Turbidity Decision Tree

Process Evaluation and Survey Results

June 17, 2011

Turbidity Decision Tree

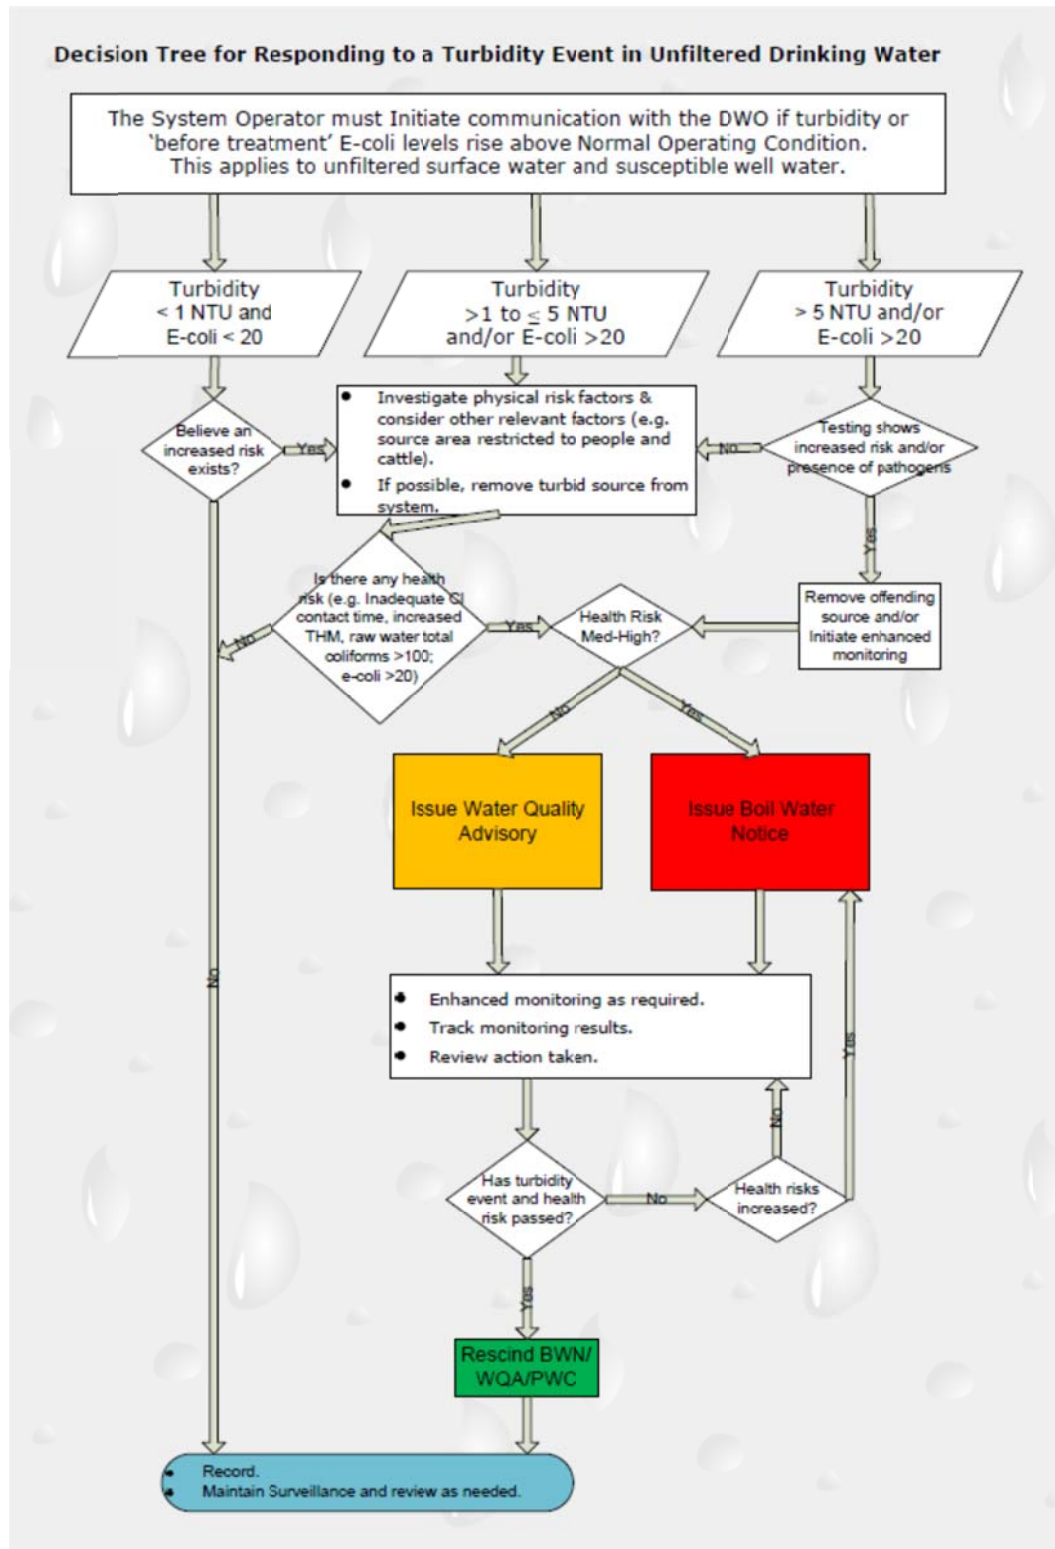
4. Box 6 of the decision tree has shifted responsibility for demonstrating risk to the DWO from the water suppliers. Some suppliers have chosen not to develop plans but engage with DWOs with the expectation of a prescribed approach.

5. The value of enhanced monitoring suggested under Box 6 is unclear as it delays action to provide public notification. Investigation (e.g. source assessment, sampling) needs to happen before the event occurs.

6. Box 8 has been problematic, assessment results tend towards a moderate or high risk.
7. The explanatory note for Box 10 results in a great deal of subjectivity. The TDT should provide direction to support greater consistency.

5. The definition and intent of "normal operating conditions" under Box 1 needs to be expanded upon. Systems often have seasonal reoccurring conditions that may pose an elevated risk. Non-freshet events (e.g. landslide) should be treated as high-risk until evidence is provided to suggest otherwise. The concept of acceptable water system operating parameters should be included in

6. Boxes 2, 3 & 4 do not specify whether the given ranges (<1, 1-5, >5) are to be considered over a specified time period (i.e. 24 average) or a single event. Further elaboration is needed on this and what information is needed when considering if a notice should be lifted.

10. Box 9, increased risk needs more guidance. The issue with the tree is the interpretation of whether the risk level is raised or not. How to define there is no increased risk.

1. As the chart is designed, box 6 works for Boxes 3 and 5, but it doesn't work for box 7 because risk assessment is already an inherent part of box 7 – the No arrow from Box 7 should go directly to Box 12. Also the text in Box 12 should be re-worded to say "If the appearance of the water

changes or is expected to change issue public health communication and provide the reason for the communication.”

2. Box 6 – Enhanced monitoring likely wouldn’t be relevant here because of the time involved. The decision on whether or not there is increased risk will be immediate in most cases.
Box 10 – this part of Appendix A is shown as “Uncertain Risk” on the chart but the title (in the text) Issue Water Quality Advisory which means the box and text are out of synchronization. It appears that this lack of synchronization is carried through the rest of Appendix A.

Need to add information to the appendix for box 1 to clarify that a freshet that normally happens each spring and results in X NTU is not normal operating conditions and thus needs to be communicated to the DWO. This does not mean that it will result in a BWN if there is historic information showing testing does not show increased pathogens at this level during this season fluctuation. But this argument would not hold for a case where an unexpected turbidity event was encountered.

Box 6 follows the same logic as the added explanation for box 1 above, wherein the only reasonable explanation to justify that there is no increased risk would be based on historic information. All other evidence would take at least a day.

12 Appendix D, Option 2:

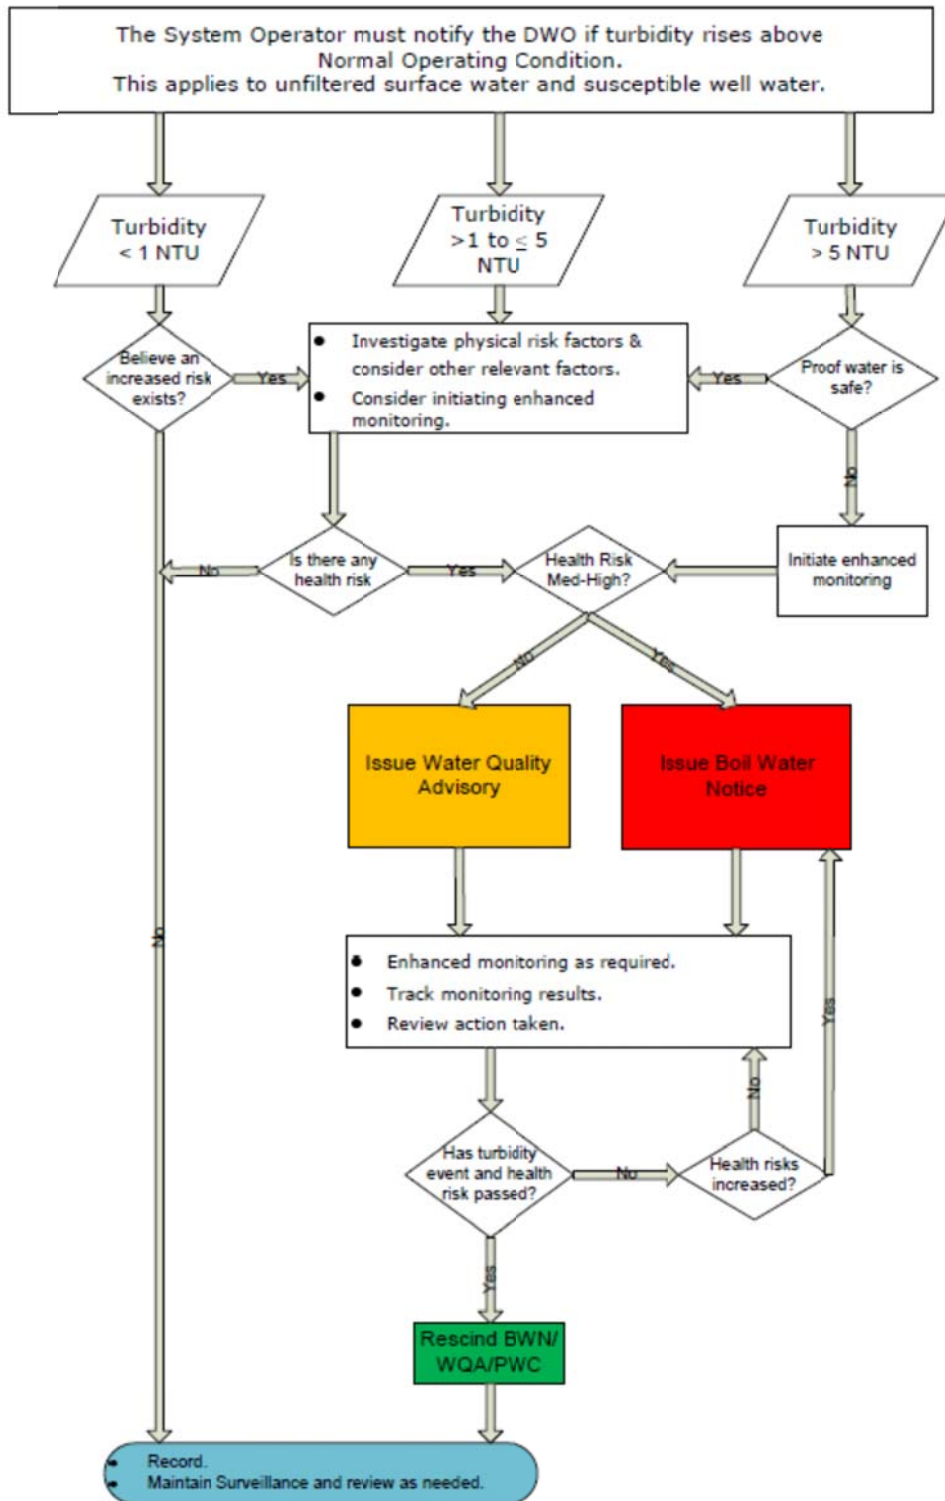
Option 2: This option is similar to the original TDT, and so will be easiest to integrate. However, this version does not adequately address the issues raised with respect to the ability to clarify the meaning or interpretation of increased/decreased or high/medium/low risk.

13 Appendix E, Option 3:

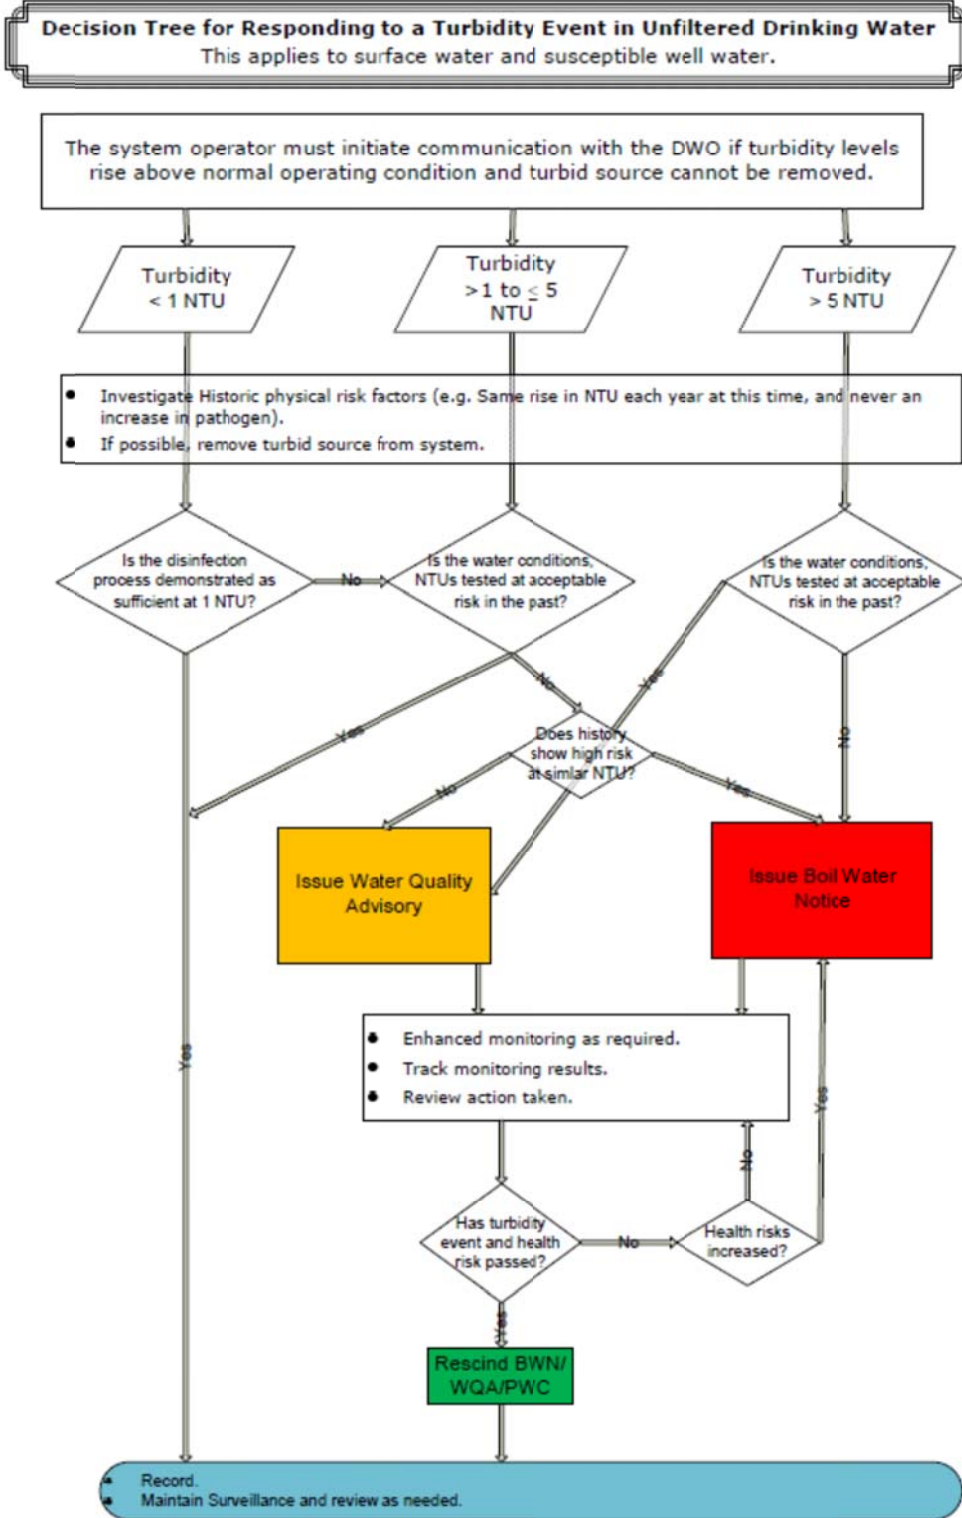
Option 3: Here the concept of proving there is a certain risk level has been removed and replaced with the determination of the past history of similar turbidity events. So the supplier would come to the DWO with notice of a turbidity level above normal, but will also need to have data showing that similar turbidity events under similar conditions in the past have proven safe based on testing. Otherwise some sort of notice will be required.

Option 3 should be considered the model going forward. This is based on discussion at DWLC and a subsequent conversation with MoH and IHA. The tree should be re-titled to reflect it's primary function as a model for an SOP to be pre-approved between the DWO and the water supplier. This would include using historic data and information to create pre-determined scenarios that would result in low risk (e.g. spring freshet in June resulted in no elevated path for the past 5 years, and the additional turbidity is mainly inorganic). The secondary function would be use during an event that is not expected. In this
